Avalon Rare Metals Inc.

**RESPONSE TO THE JANUARY 13, 2012 INFORMATION REQUESTS FROM
ABORIGINAL AFFAIRS AND NORTHERN DEVELOPMENT CANADA
FOR THE THOR LAKE RARE EARTH ELEMENT PROJECT
DEVELOPER'S ASSESSMENT REPORT**

**Submitted To:
MACKENZIE VALLEY ENVIRONMENTAL IMPACT REVIEW BOARD**

February 2012

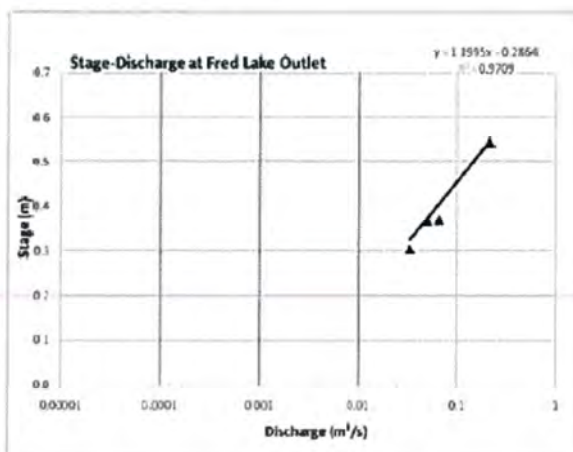
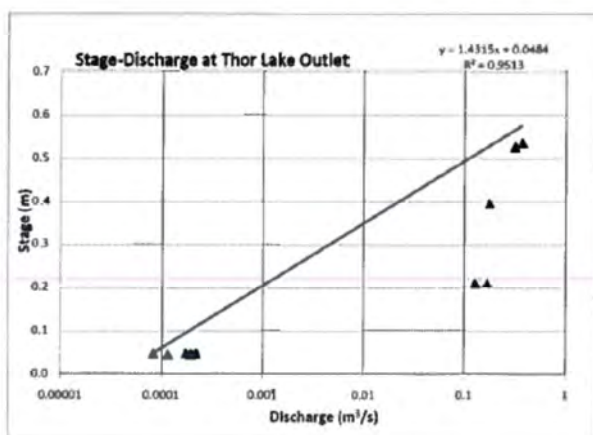
In section 2.5.2 of the DAR (p50), it is stated that 'water flows from Thor Lake to Fred Lake through a defined channel that has a 1.5 m waterfall near its outlet', and is simulated accordingly in all water balances. In 2009 (Figure 2.5-8, p.58 of the DAR), both measured and estimated discharges appear to be greater at Thor Lake than Fred Lake and the causes of this pattern are not immediately apparent. The potential source of error in estimated flows using rating curve information is outlined below. In 2008, the opposite occurred and flows from Fred Lake were consistently higher, with observations that a debris blockage altered flow patterns between the two lakes. In 2010, discharge was higher from Fred Lake outlet in May and October, and vice versa from June-September.

Related to this, in the rating curve developed from Stantec's measurements for Thor Lake Outlet (see below), please note that the rating curve developed for Thor Lake incorporates measurements obtained under very different stream conditions during 2008 (outlet blocked by debris; all flows less than $0.01 \text{ m}^3/\text{s}$) and 2009 (outlet not blocked from June; flows all above $0.1 \text{ m}^3/\text{s}$).

Avalon Response #14.1

Figure 6: Pine Point area Groundwater Flow Model Constant Head Boundaries shown in Blue and River Boundaries shown in Red

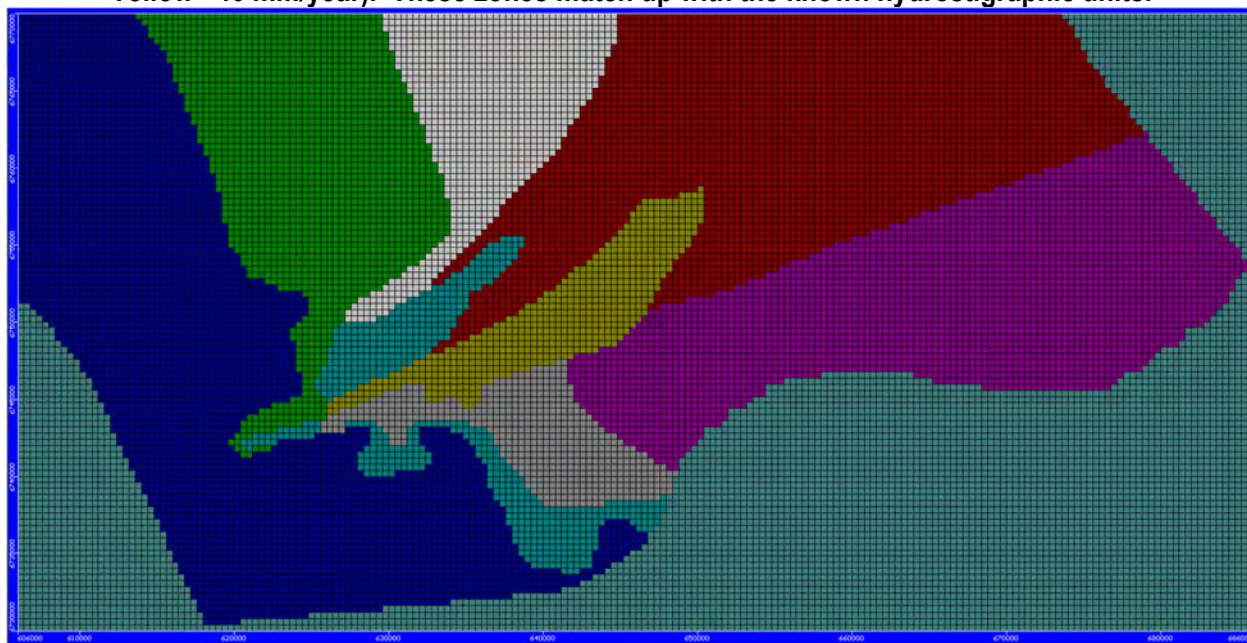
1. Explain discrepancy between rate of groundwater extraction used for water balance ($695 \text{ m}^3/\text{day}$ in figure 4.8-7) and rate used in modeling for impact assessment ($1,950 \text{ m}^3/\text{d}$).
2. Describe model domain and model discretization (including a figure showing FD grid).
3. Describe boundary conditions used (including a figure showing the BCs in MODFLOW).
4. Specify aquifer thickness assumed in model (specifically near the pits to be used).
5. Specify recharge assumed for the steady-state model.
6. Provide details on model calibration, model convergence and model water balance.
7. Clarify assumption on type of aquifer (Confined vs Unconfined).
8. Explain what, if any, effects the high TDS of the process water (saline seepage) has on local groundwater flow and migration of the seepage plume in the local aquifer.

- Great Slave Lake and regional groundwater flow from the south of the Pine Point area were represented using the River package.
- Buffalo River and Little Buffalo River were represented using the Constant head package.
- Meteoric recharge was represented using the Recharge package. Recharge was applied to areas of relatively higher hydraulic conductivity (i.e., Watt Mountain Limestone, Sulphur Point Formation, Presqu'le Formation).
